# Access Compliance Report

## Public Rights-of-Way

Intersection ID: 9807	Main Street: TINNIN_AV	Cross Street: DOUBLE_OAKS_RD	Location: NW
ADA ID: 7C13D59D7174	Ramp Type: Perp	Initial Pass/Fail: Fail	Overall Compliance: No
			Severity Score: 33.75

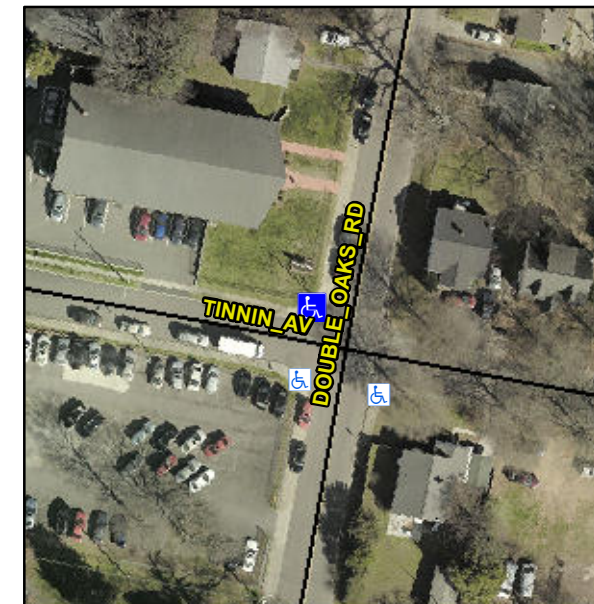
**Remove & Replace Entire Ramp.**

**R304.5.1, R304.5.3**

Compliance	Description	Data	Compliance	Description	Data
N/A	Ramp Length (in)	68.0	Yes	Ramp Slope (%)	6.1
No	Ramp Width (in)	43.0	No	Ramp XSlope (%)	7.3
N/A	Flare Type LT	N/A	N/A	Flare Type RT	N/A
N/A	Flare Slope LT (%)	N/A	N/A	Flare Slope RT (%)	N/A
N/A	Flare Traversable LT?	N/A	N/A	Flare Traversable RT?	N/A
N/A	Landing Length (in)	N/A	N/A	DWS Provided?	N/A
N/A	Landing Width (in)	N/A	N/A	DWS Contrast?	N/A
N/A	Landing Slope (%)	N/A	N/A	DWS Length (in)	N/A
N/A	Landing X Slope (%)	N/A	N/A	DWS Full Width?	N/A
N/A	Landing Curb? (Y/N)	N/A	N/A	DWS Offset (in)	N/A
N/A	Shared Landing?	N/A			
N/A	Gutter Ponding?	N/A	N/A	Gutter Slope (%)	N/A
N/A	Gutter Lip Ht (in)	1.0	N/A	Gutter X Slope (%)	N/A
N/A	Painted X Walk1?	No	N/A	Painted X Walk2?	N/A
	X Walk 1 Direction	To S		X Walk 2 Direction	N/A
N/A	X Walk 1 Width (in)	N/A	N/A	X Walk 2 Width (in)	N/A
	X Walk 1 Slope (%)	1.1		X Walk 2 Slope (%)	N/A
	X Walk 1 X Slope (%)	7.2		X Walk 2 X Slope (%)	N/A
